Re: St. Lucie Unit 1  
Docket No. 50-335  
Response to Request for Additional Information  
Unit 1 Third Interval Relief Request 31

**St. Lucie Unit 1  
THIRD INSPECTION INTERVAL  
RELIEF REQUEST NUMBER 31, REVISION 1**

**Relief Request  
In Accordance with 10 CFR50.55a(g)(5)(iii)**

Figure 1

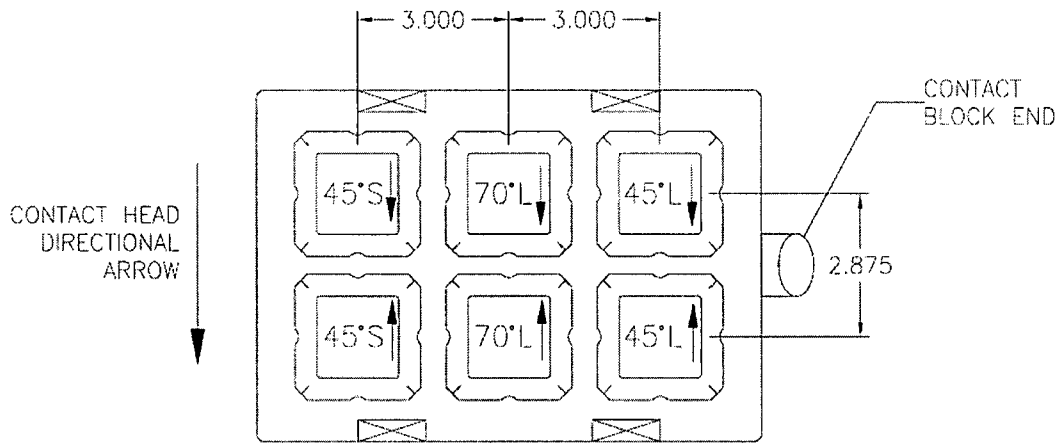
- 2.1.2 Please submit further specific information to support the basis for each limited examination in Request for Relief 31, and therefore, demonstrate impracticality. Include descriptions (written and/or sketches, as necessary) of the interferences to applied nondestructive examination (NDE) techniques. As applicable, describe NDE equipment, show accessibility limitations, and discuss whether alternative methods or advanced technologies could be employed to maximize ASME Code coverage.

FPL Response: Figure 1 has been added which provides an illustration of the contact UT head used for scanning from the vessel shell. Additional figures have been added to provide the dimensions and locations of obstructions and views of each of the affected welds showing the interference caused by the permanent attachments on the TWS robot and the affect the obstructions had on scanning. The Ultrasonic (UT) techniques for each weld were reviewed to determine if additional coverage could be achieved. For the welds included in this relief request, it is not possible to remove the permanently attached obstructions to increase ASME Code coverage without significant work, increased radiation exposure, and/or damage to the plant.

Described below, coupled with figures, are details of the examination limitations by weld description. Figure 1 provides an illustration of the contact UT head used for scanning from the vessel shell. Figures 2 through 15 provide the dimensions and locations of obstructions and views of each of the affected welds showing the interference caused by the permanent attachments on the Trans World System (TWS) robot and the affect of the obstructions on scanning.

Figure 2

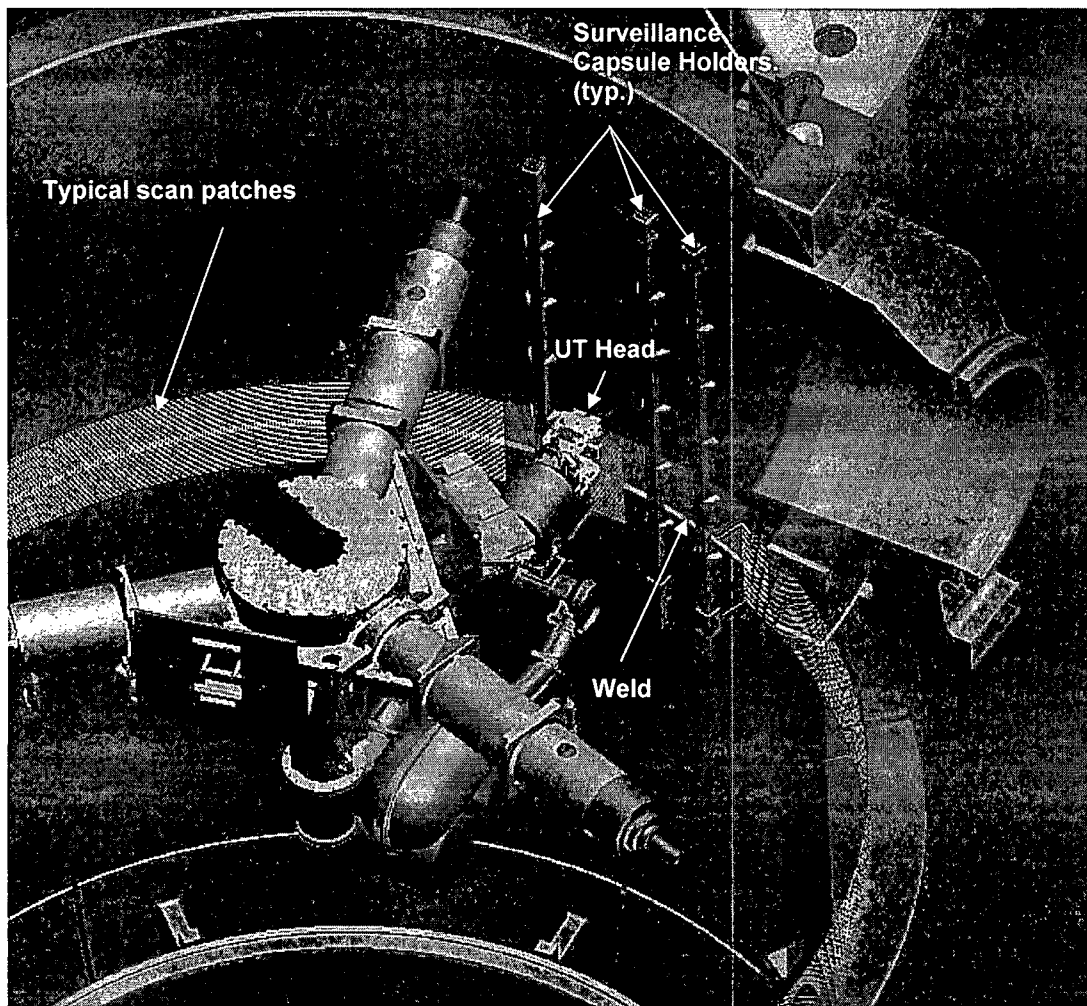
The licensee requested relief from examining 100% of the ASME Code-required volumes for RPV welds: Shell-to-Lower Shell Circumferential Weld (9-203), RPV Circumferential Bottom Head-to-Lower Shell Weld (10-203), RPV Upper Shell Longitudinal Seam Weld at 15 Degrees (1-203B) and RPV Lower Head Peel Segment Welds (204-03-A through F). The licensee has provided technical descriptions and sketches; however, it is unclear from the licensee's submittal how these appurtenances specifically limit the subject examinations. For example, the roll-out sketches do not provide dimensions and there is no description of the ultrasonic scanning apparatus, or any other details of the listed obstruction (e.g., size, shape, proximity to the weld, etc.).

The examination of the Figure IWB-2500-2 A-B-C-D volume is limited due to the six surveillance capsule holders. Access to approximately 16.9% of the examination volume is restricted. The remaining examination volume was examined with techniques which have been qualified by demonstration in accordance with Supplements 4 & 6 of the 1995 Edition with Addenda through 1996 of the ASME Code Section XI, Appendix VIII, using the Performance Demonstration Initiative Protocol. This weld was examined from both sides of the weld, scanning both parallel and perpendicular. These ultrasonic examinations did not reveal any recordable or reportable flaws in accordance with the ASME Code Section XI, 1989 Edition, No Addenda.

Figure 2 is a view of the TWS robot in the vessel shell region showing scan limitations caused by the six surveillance capsule holders. The weld is covered by the six surveillance capsule holders. Figure 3 provides dimensional information for the six surveillance capsule holders and their affect on scanning. Figure 4 is a roll out view showing the reactor vessel inside surface scan areas (cross hatched) and the locations of limited areas due to the presence of the six surveillance capsule holders.
